RS-22-084

Subject: Response to Request for Additional Information - Proposed Alternative for Examinations of Examination Categories B-B, B-D, and C-A Steam Generator Pressure Retaining Welds and Full Penetration Welded Nozzles

Attachment

Response to Request for Additional Information

Figure RAI 6-1: Applied K vs. Fracture Toughness as a Function of Temperature for Case ID SGPNV-P1A-(N)
(Using Braidwood Unit 2 and Byron Unit 2 Plant-Specific Upper Bound SG Material RT_{NDT} Value of 60°F)

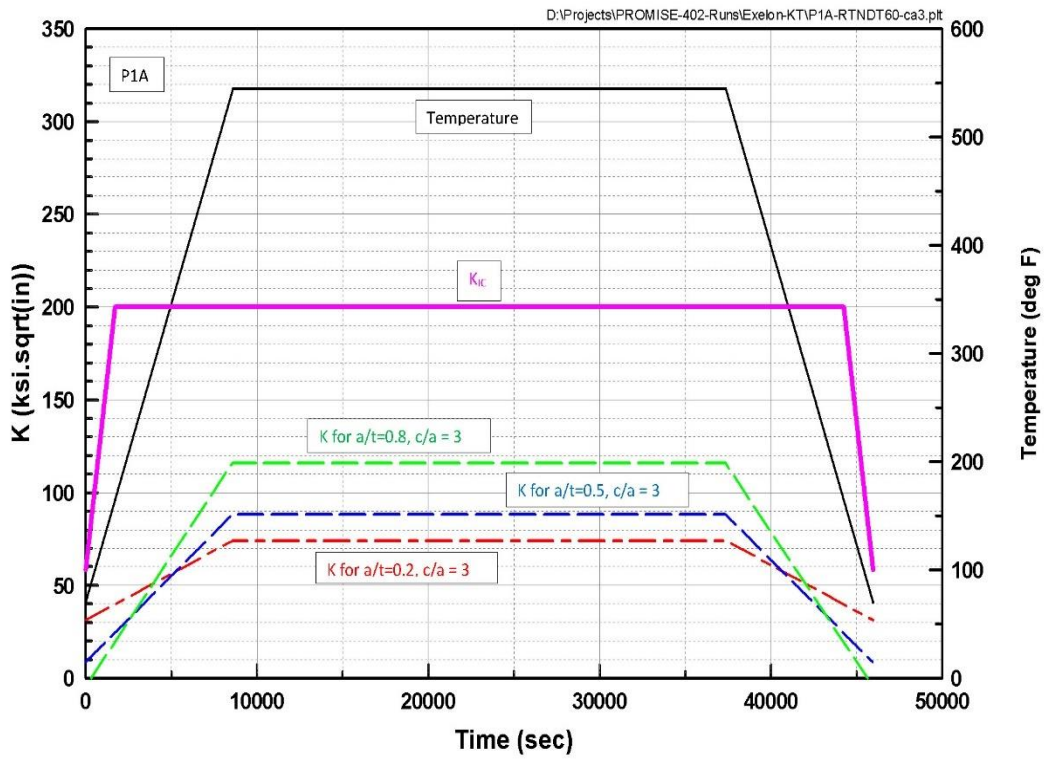
For the B2.40 and B3.130 welds of the subject units requested in the submittal, the tables in Appendix A to the submittal that show the transient cycles for each of the units also show the lowest temperatures for the Heatup/Cooldown transient for each unit: 120°F for Braidwood and Byron (Tables A3, A4, A7, and A8), 70°F for Calvert Cliffs (Tables A12 and A13), and 100°F for Ginna (Tables A16 and A17). Section 8.2.2.5 of EPRI report 15906 states that the minimum temperature (200°F) during this transient corresponds to Figure 7-22 of EPRI report 15906; therefore, a fracture toughness (K_{IC}) set at the upper shelf value of the ASME Code K_{IC} curve, 200 ksi√in, may be used. The NRC staff noted that Figure 7-22 of EPRI report 15906 is at the

end of heatup (as noted in the figure). During the ramp periods at the beginning and end of the Heatup/Cooldown transient, the temperatures at the subject B2.40 and B3.130 welds of the subject units could be lower than 200°F as indicated in the above tables, and thus, K_{IC} could be lower than 200 ksi√in. A similar issue was addressed for Millstone 2 in letter dated March 19, 2021 (ADAMS Accession No. ML21081A136) through plots that compare the K_{IC} history for the Heatup/Cooldown transient, which were determined based on a plant-specific RT_{NDT} value of 0°F for the Millstone 2 SG, with the corresponding applied stress intensity factor history (Figures RAI-4-1 and RAI-4-2 in the March 19, 2020 letter). The comparison showed that the applied stress intensity factor during anytime of the Heatup/Cooldown transient did not exceed the lowest K_{IC} plant-specific value for Millstone 2 and was accepted by the NRC staff in the safety evaluation dated July 16, 2021 (ADAMS Accession No. ML21167A355).

Show that the applied stress intensity factor at the B2.40 and B3.130 SG welds of the subject units during anytime of the Heatup/Cooldown transient does not exceed the lowest plant-specific K_{IC} value for each subject unit that occur at the beginning and end of the Heatup/Cooldown transient.

For the original SG materials at Braidwood Unit 2 and Byron Unit 2, the maximum RT_{NDT} value is guaranteed to be no greater than 60°F. Although the actual values are expected to be lower, records were not readily available to determine the exact value and therefore the maximum value of 60°F is assumed. For the original SG material at Calvert Cliffs Units 1 and 2, the maximum RT_{NDT} is 40°F. It should be noted that the original SGs at Calvert Cliffs Units 1 and 2 do not contain the critical Case ID SGPTH-4A in the Reference [7] EPRI Report which is associated with the tubesheet-to-head weld (Item No. B2.40) on the primary side. The Item Numbers associated with the original SGs at Calvert Cliffs Units 1 and 2 are C1.10 and C1.20. Tables 8-3 and 8-13 through 8-16 of the Reference [7] EPRI Report indicate that there are significant margins in the analysis for these Item Nos with respect to fracture toughness. As such, the SGs at Braidwood Unit 2 and Byron Unit 2 are bounding since they contain the critical Case ID and have the highest RT_{NDT} value. An evaluation similar to that performed in response to RAI 4 for Millstone Unit 2 in ADAMS Accession No. ML21081A136 [10] was repeated using the limiting RT_{NDT} value of 60°F to address the original SG materials at Braidwood Unit 2 and Byron Unit 2. The two Case IDs considered for Millstone Unit 2 (SGPNV-P1A(N) and SGPTH-4A) were also evaluated in this case. The results are shown in Figures RAI 6-1 and RAI 6-2 for Case IDs SGPNV-P1A(N) and SGPTH-P4A, respectively.

As can be seen in Figure RAI 6-1, for Case ID SGPNV-P1A(N), the applied stress intensity factor (K) is below the fracture toughness throughout the transient; however, for Case ID SGPTH-4A, the applied K is higher than the allowable fracture toughness in the beginning part of the heatup transient and at the end of the cooldown transient, with the allowable fracture toughness between 72 ksi√in to 86 ksi√in. Figure 8-6 of the Reference [7] EPRI Report shows that the 80% and 50% through-wall flaws evaluated in Figure RAI 6-2 would have been detected by the POD curve in the PFM evaluation, resulting in the allowable fracture toughness of 86 ksi√in being the most realistic case. Therefore, conservative lower bound fracture toughness of 80 ksi√in at the beginning of heatup and end of cooldown for the Case ID SGPTH-P4A is used to perform a sensitivity study on fracture toughness. This is similar to the sensitivity study performed in Table 8-14 of the Reference [7] EPRI Report, where it was demonstrated that fracture toughness as low as 80 ksi√in would meet the acceptance criteria.
